CITY OF KELOWNA
MEMORANDUM

Date: September 1, 2016
File No.: Z16-0050
To: Community Planning (KB)
From: Development Engineering Manager (PI)
Subject: 3580 Casorso Rd RU1 to RU2

PROPOSED SUBDIVISION PLAN OF LOT 16
 DISTRICT LOT 134 ODYD PLAN 20399

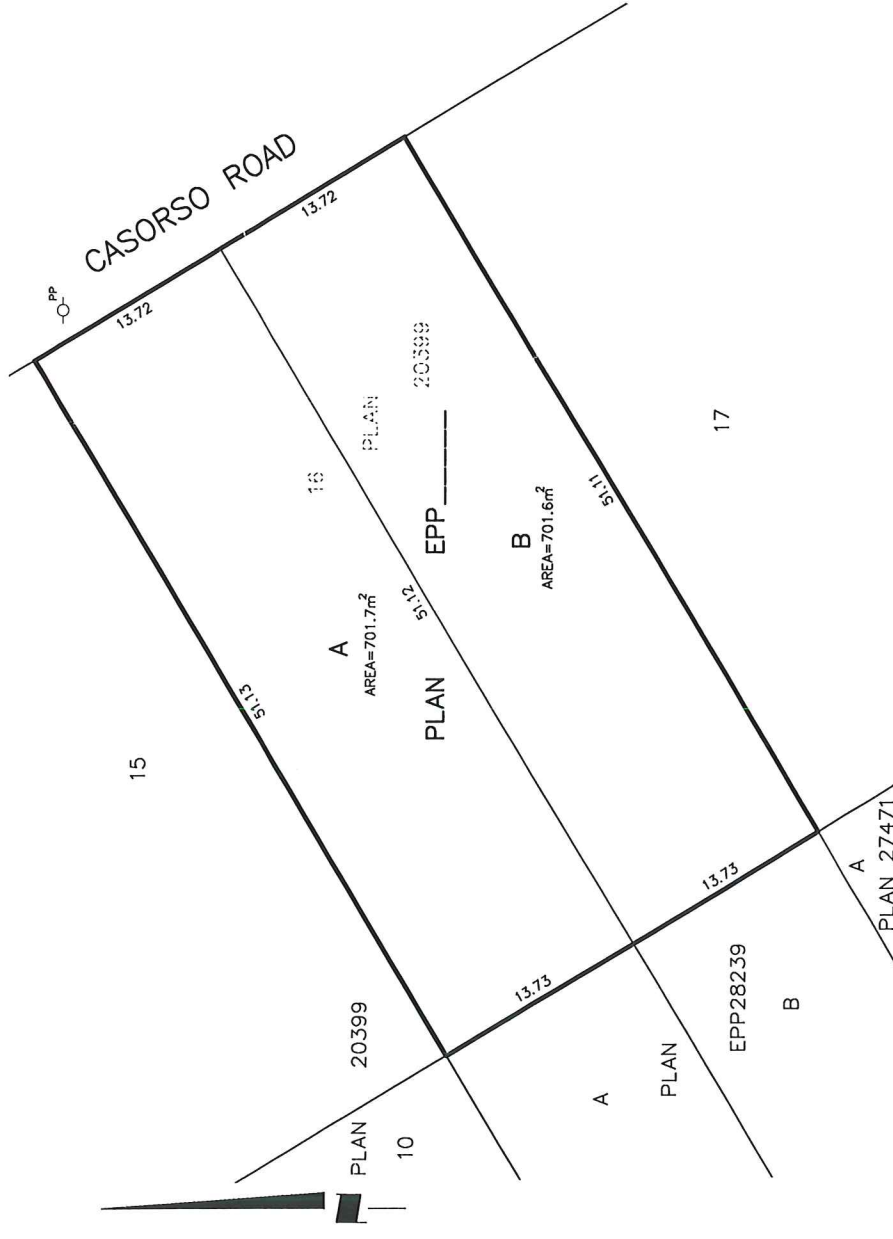
The proposed redevelopment includes the subject parcels being subdivided into two lots. A subdivision application will require service upgrades that include the installation of additional services. The work will require road cuts and boulevard and pavement restoration. Development Engineering is prepared to defer the requirements of the rezoning to the subdivision stage.
